Subject: Duke Energy Carolinas, LLC.  
William States Lee III Nuclear Station - Docket Nos. 52-018 and 52-019  
AP1000 Combined License Application for the William States Lee III  
Nuclear Station Units 1 and 2  
Response to Request for Additional Information  
(RAI Nos. 1156 and 1162)  
Ltr # WLG2008.012-08

**Lee Nuclear Station Response to Request for Additional Information (RAI)**

**Reference NRC RAI Number(s): RAI 12.03-12.04-001**

**Reference NRC RAI Number(s): RAI 12.03-12.04-002**

Figure 1

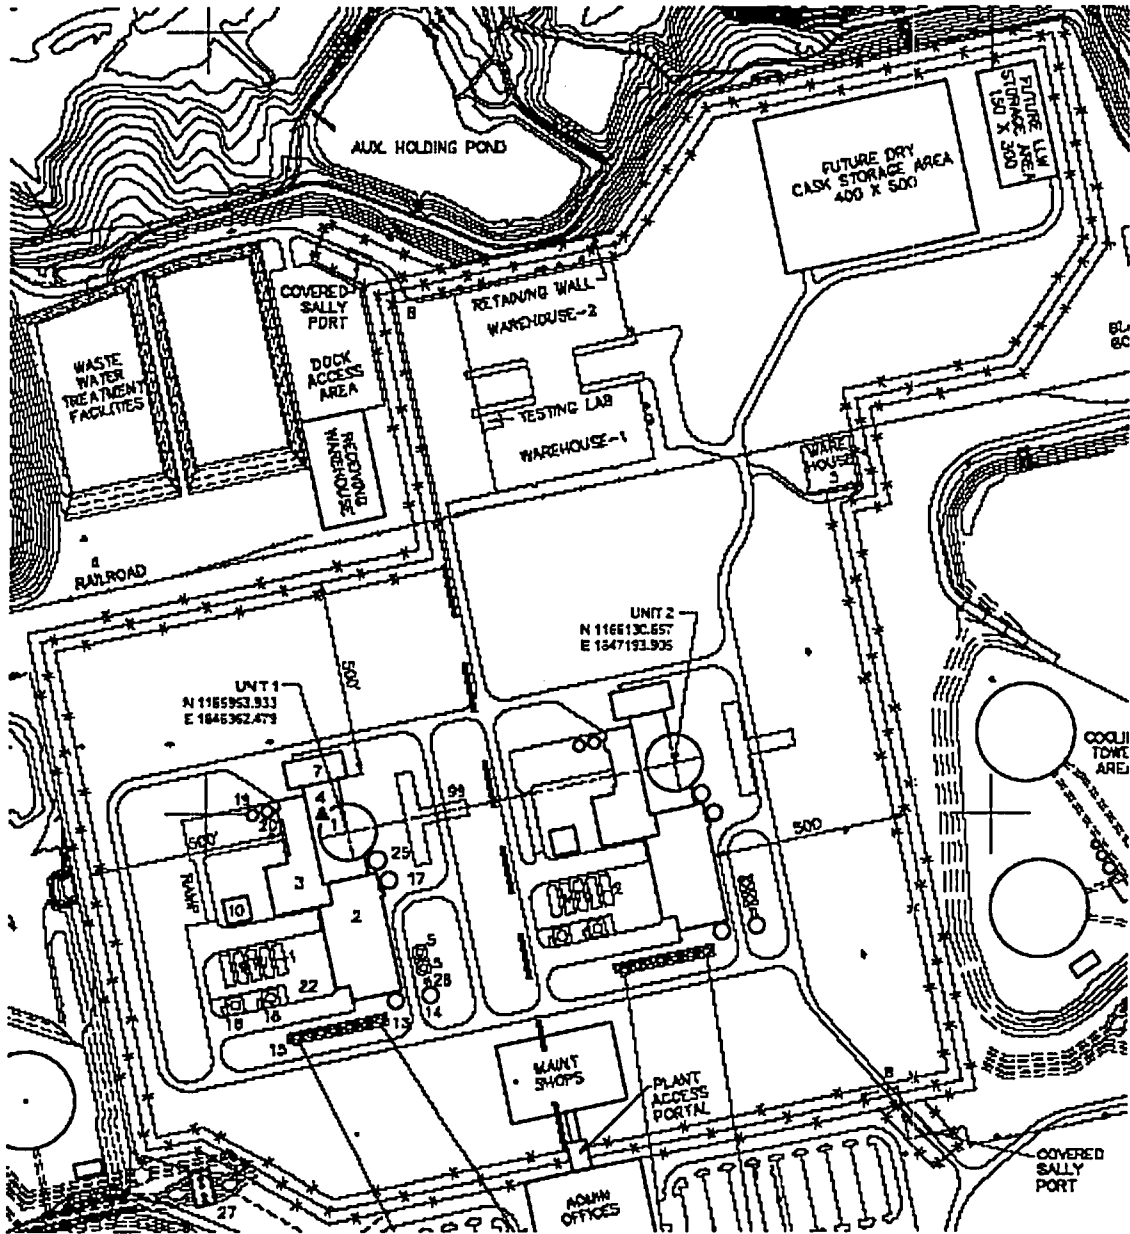
The WS Lee III FSAR states that the dose to Unit 2 construction workers from liquid effluents is minimal due to the tie-in of the Unit 2 piping and dose at the Unit 2 shield building construction area. The FSAR does not contain sufficient information describing the applicants' conclusion that minimal exposure of Unit 2 construction workers results from liquid effluents due to the tie-in of the Unit 2 liquid effluent piping.

Section 12.4.1.9.4 states that for an occupational year (i.e., 2080 hours on site), dose at the Unit 2 shield building construction area would be 0.29 mrem Total Effective Dose Equivalent (TEDE). The applicant also states that the maximum dose anywhere on site that would be accessible to a construction worker would be 5.9 mrem per year in the southeast sector at the Unit 1 fence line.

The discussion of the Unit 2 shield building dose does not provide information as to the source of that dose (i.e., is it due to direct exposure from Unit 1, building wake effects of the air effluent, etc.?) or as to the derivation of that annual exposure.

Provide the necessary information to confirm the FSAR calculation results and revise the FSAR Section 12.4 to provide sufficient information to demonstrate compliance with 10CFR20.1301.

Doses are determined at the principal area of construction for Unit 2, the nearest point of the shield building which is near the center of the power block of Unit 2. Doses are also determined at locations where particularly high dose rates could be expected, at the fence surrounding Unit 1. The necessary information to confirm the construction worker dose calculation results is

provided in FSAR Section 12.4 and in Figure 1 and Table 1 of this response. Figure 1, which is taken from FSAR Figure 1.1-202, shows the fence surrounding Units 1 and 2 as well as the assumed fence line between Units 1 and 2, which is shown with a dashed red line. The location of the Unit 1 plant vent, the location of most significant normal gaseous effluent releases, is approximated in Figure 1 with a red triangle on the northwest side of the shield building. Figure 15A-1 of the AP1000 DCD provides a more accurate location of the plant vent. Table 1 provides the  $\chi/Q$  and  $D/Q$  values calculated at the distances from the Unit 1 plant vent to the nearest point on the assumed fence line surrounding Unit 1 in each of the 16 directional sectors. Lee Nuclear Station site meteorological data for the year beginning December 1, 2005 and ending November 30, 2006, was used in determination of  $\chi/Q$  and  $D/Q$  values. Releases were conservatively modeled as ground-level releases. A conservative cross-sectional area of 1500 m<sup>2</sup> and height of 71 m for the shield building were used to evaluate the effects of building wake. A discharge height of 56 m for the plant vent was used in the calculation. No terrain correction was necessary because the construction area surrounding Units 1 and 2 is flat.
